PUBLIC UTILITIES COMMISSION OF THE STATE OF CALIFORNIA

**RESOLUTION SU-6
November 21, 1990**

**RESOLUTION SU-6, ORDER AUTHORIZING RULE CHANGES TO
GENERAL ORDER NO. 95 (G.O.95), RULES FOR OVERHEAD
ELECTRIC LINE CONSTRUCTION AND GENERAL ORDER NO. 128
(G.O.128), RULES FOR CONSTRUCTION OF UNDERGROUND
ELECTRIC SUPPLY AND COMMUNICATION SYSTEMS**

PROPOSED RULE CHANGES

FIGURE 54-

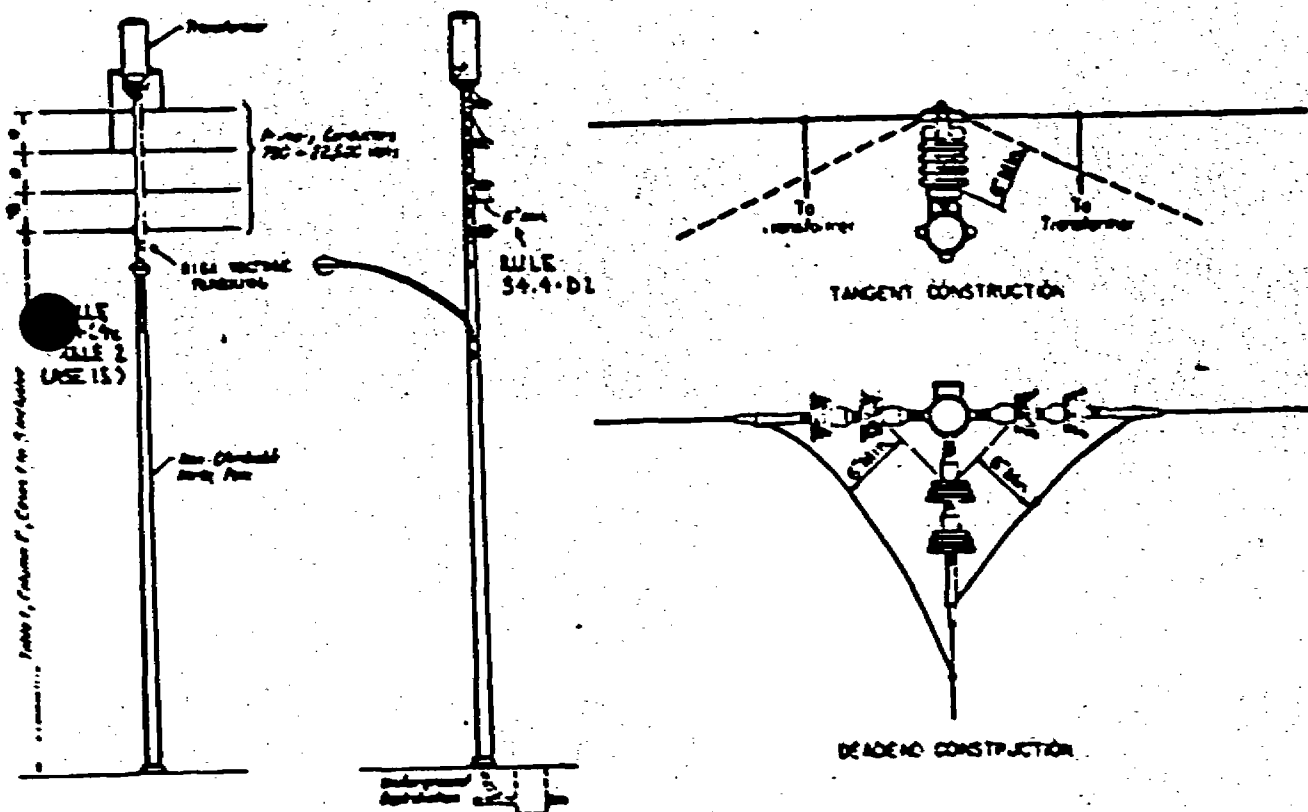
The requirement of not allowing more than three conductors of a single circuit of 750-22,500 volts to be supported (dead ended) directly on the pole in vertical configuration without the use of crossarms should be changed to allow four conductors. This change will allow safe, cost effective conversion of three-phase three wire 12 KV. to three-phase four wire 21 KV. distribution circuits. Currently a fourth conductor can be attached to a pole in tangent construction, the restriction applies to dead end configuration only.

Not more than ~~four~~ four conductors of a single circuit of 750-22,500 volts shall be supported directly on the pole in vertical configuration without the use of crossarms. Branch circuits may be taken from such construction without the use of crossarms provided that conductors are supported on not more than three sides of the pole, there being four sides.

The vertical separation ~~between~~ between conductors shall ~~not~~ not be less than the pin spacings specified in Table 2, Case 15; and

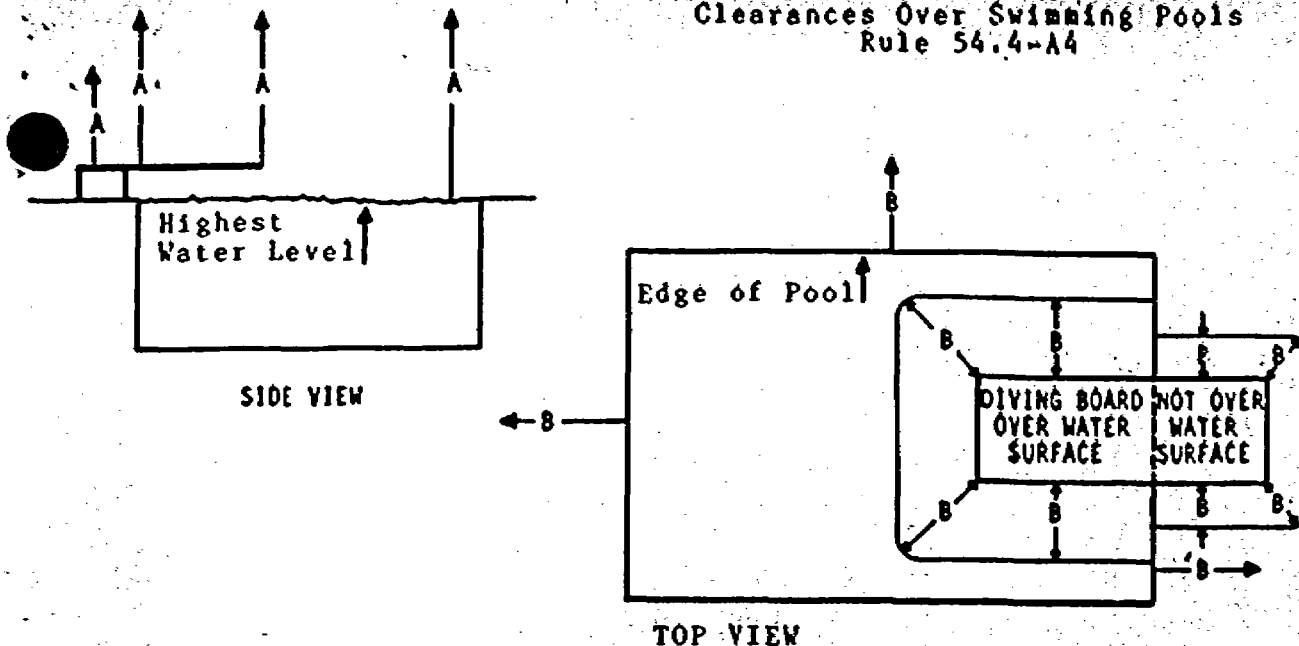
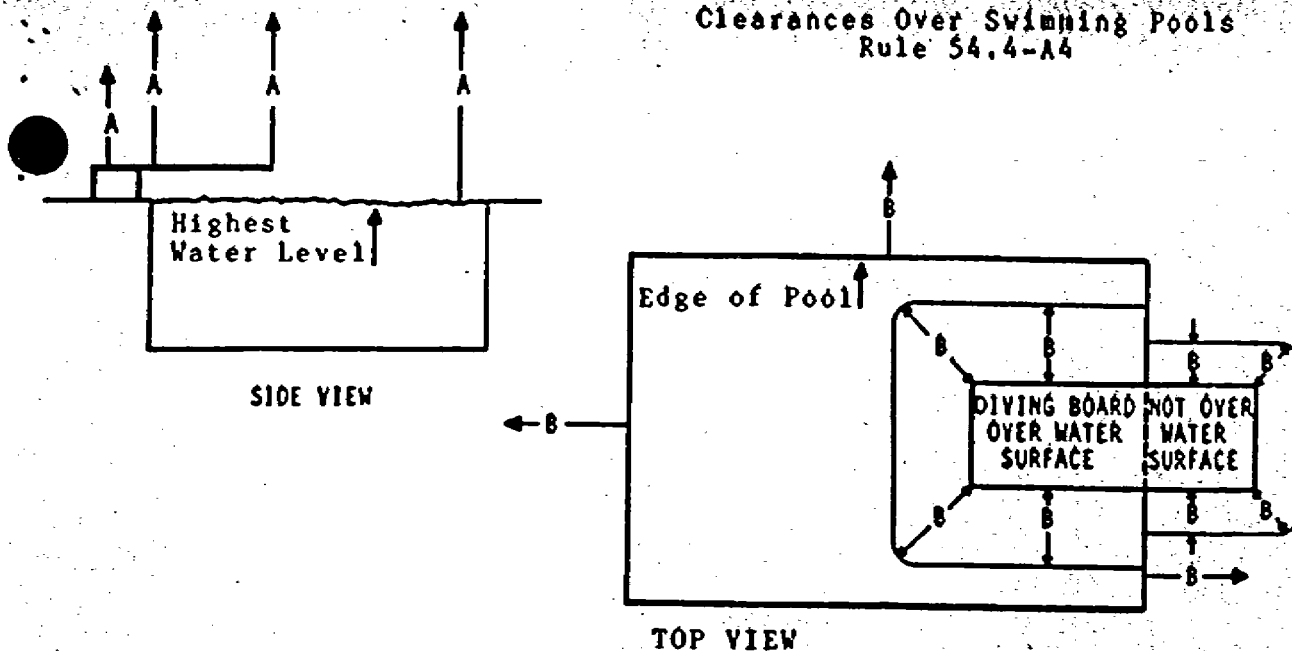
These proposed rule changes reformat the text to simplify obtaining (and clarification of) the vertical and radial clearances above swimming pools. A sketch and table (Fig. 54-8) have been added for clarification of the text.

1) Shall have vertical clearances over the highest water level of the pool surface of not less than 16 feet.

2) Shall not be installed less than 16 feet vertically above the horizontal plane through a diving board or platform, such plane being the area within 8 feet radially of the diving board or platform that is over the water surface of the pool.

3) Shall not be installed less than 8 feet vertically above the horizontal plane through a diving board or platform, such plane being the area within 3 feet radially of the diving board or platform that is not over the water surface of the pool.

1) Shall have vertical clearances above the highest water level of the pool surface of not less than 16 feet.

2) Shall not be installed less than 16 feet vertically above the horizontal plane through a diving board or platform, such plane being the area within 8 feet radially of the diving board or platform that is over the water surface of the pool.

3) Shall not be installed less than 8 feet vertically above the horizontal plane through a diving board or platform, such plane being the area within 3 feet radially of the diving board or platform that is not over the water surface of the pool.

FIGURE 84-1
CLEARANCES OVER SWIMMING POOLS
RULE 84.4-A5

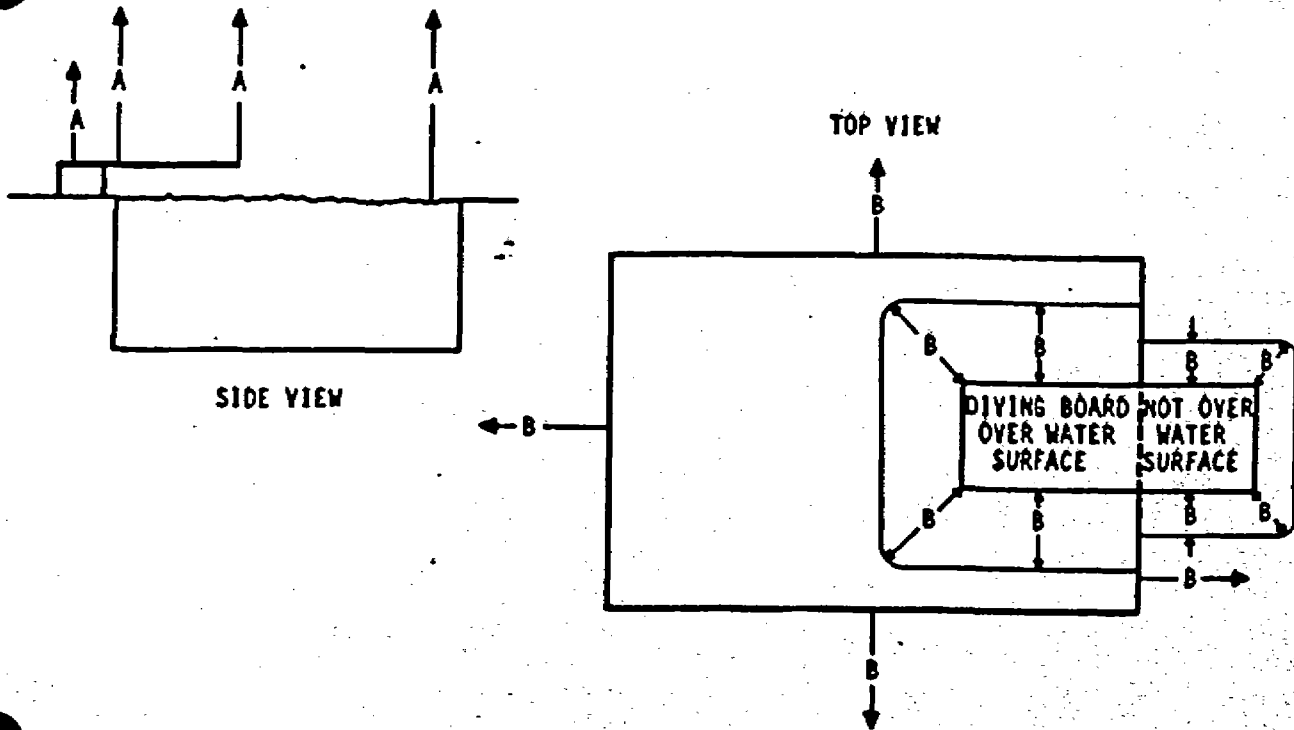
These proposed rule changes reformat the text for communication conductors, service drops and guys to give clarification and descriptive detail to vertical, horizontal and radial measurements and include the addition of a sketch (Figure 84-1) which consists of a top and side view of a typical pool with a diving board.

Additionally, the proposed rule change eliminates reference to the material composition of communication service drops. Resolution No. E-1109 approved material for use in supply service drops in Rule 54.8-B5 and was not intended to be placed in the communication section (Section VIII).

1. (5) Over Swimming Pools (See Figure 84-1):
2. (a) Line Conductors, Cables, Messengers and Span Wires: Crossings
3. of communication line conductors over swimming pools shall be avoided

19. pools.
20. No service drop may be installed less than 14 feet vertically over
21. the horizontal plane through a diving board or platform, the area of

22. such plane being within 8 feet radially of the diving board or
23. platform and over the water surface of the pool.

24. No service drop may be installed less than 10 feet vertically over
25. the horizontal plane through a diving board or platform, the area of
26. such plane being the area within 3 feet radially of the diving board

CLEARANCES OF COMMUNICATION
 CONDUCTORS AND CABLES
 RULES 64.4-D1 AND
 87.4-03

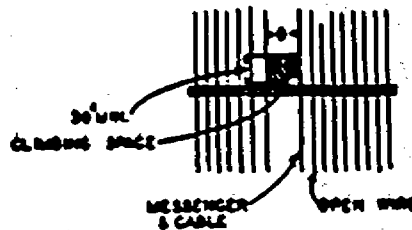
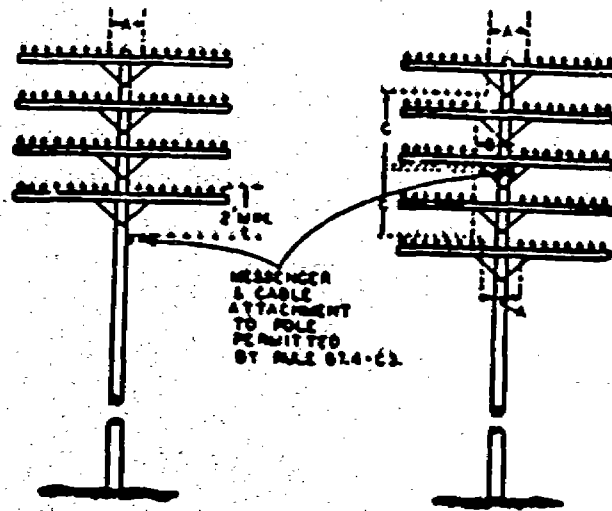
43. Any conductor supported on a crossarm and on the opposite
44. side of the pole that is within 36 inches vertically of
45. the cable or messenger shall be at least 18 inches
46. horizontally from the vertical plane of such cable or
47. messenger (see Appendix B Fig. 84.2).

23. that is within 36 inches vertically of the cable or messenger shall
24. be at least 18 inches horizontally from the vertical plane of such
25. cable or messenger (see Fig. 84-2).
